# Modification Recommended Service Note

## N8955A - Autoranging System DC Power Supply, 750V, 60A, 15000W, 400 VAC

Serial Numbers: DE14290000 - DE15369999 without manufacturing ID Version "B"

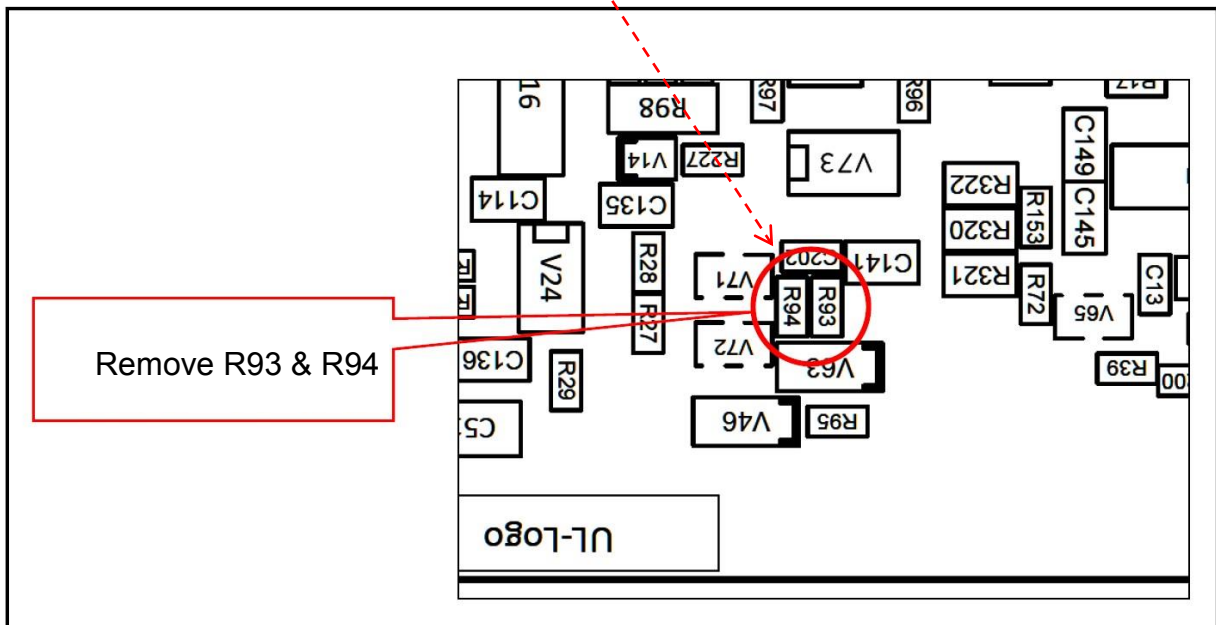
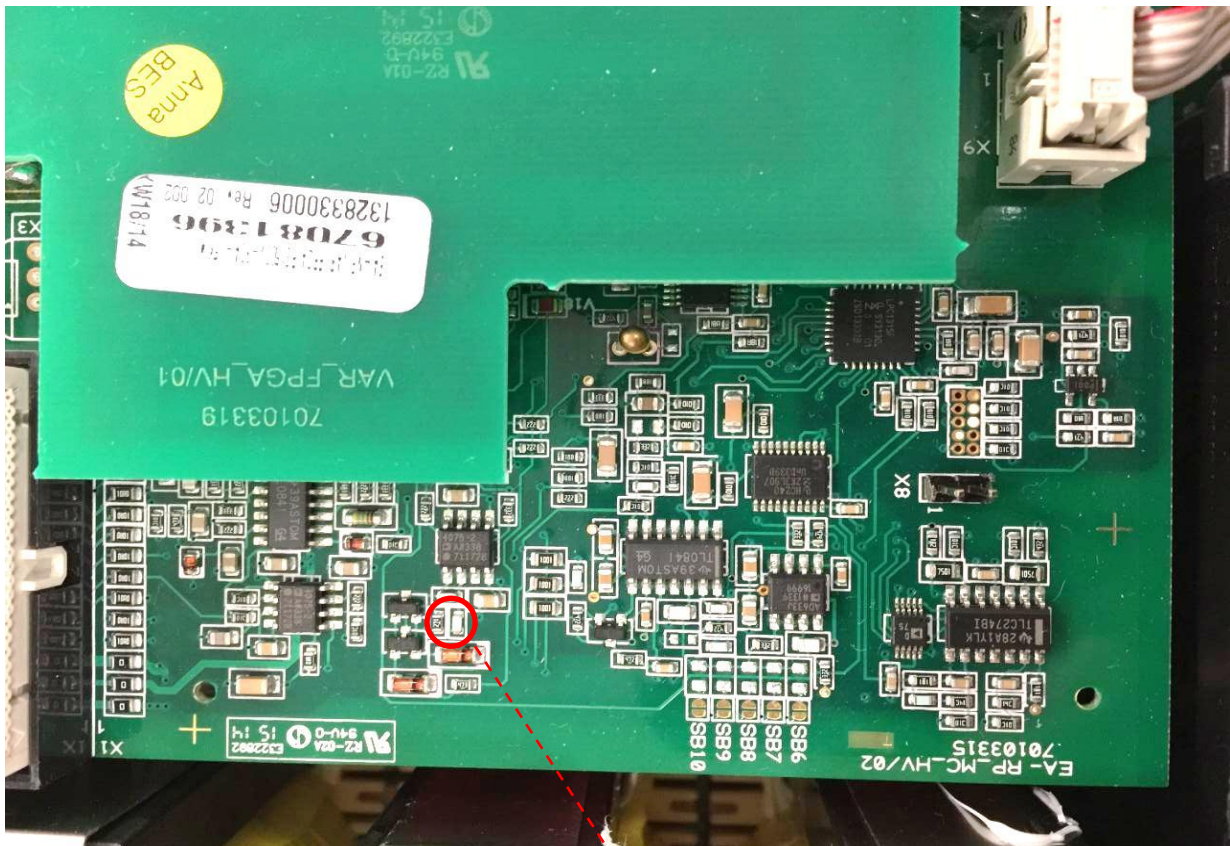
- 1) Remove acMains cable from power source.
- 2) Wait 5 minutes
- 3) Remove top cover from instrument.
- 4) In the 5kW units (viewed from the front of the unit), a small SMT assembly located at the right-rear of instrument will be readily visible (see below):

In the 10kW & 15kW units; although found in the same location, a black plastic cover will have to be removed to gain visibility and access to the SMT assembly. Plastic cover snaps-on and can be removed with a small screwdriver.

Removal of two (2) surface mount resistors, R93 and R94, will correct this problem:

Suffix “B” added

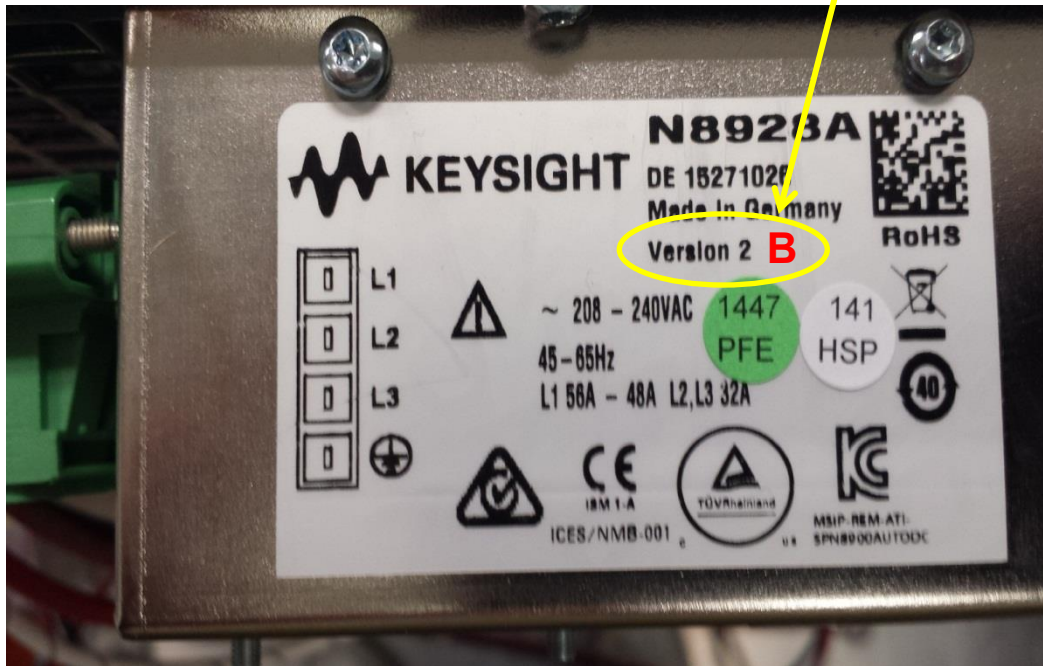
7) On the acMains label, on the rear of the instrument; use an indelible marker, to add the suffix letter “B” after the Version ID. This will assist in the tracking of modified instruments.
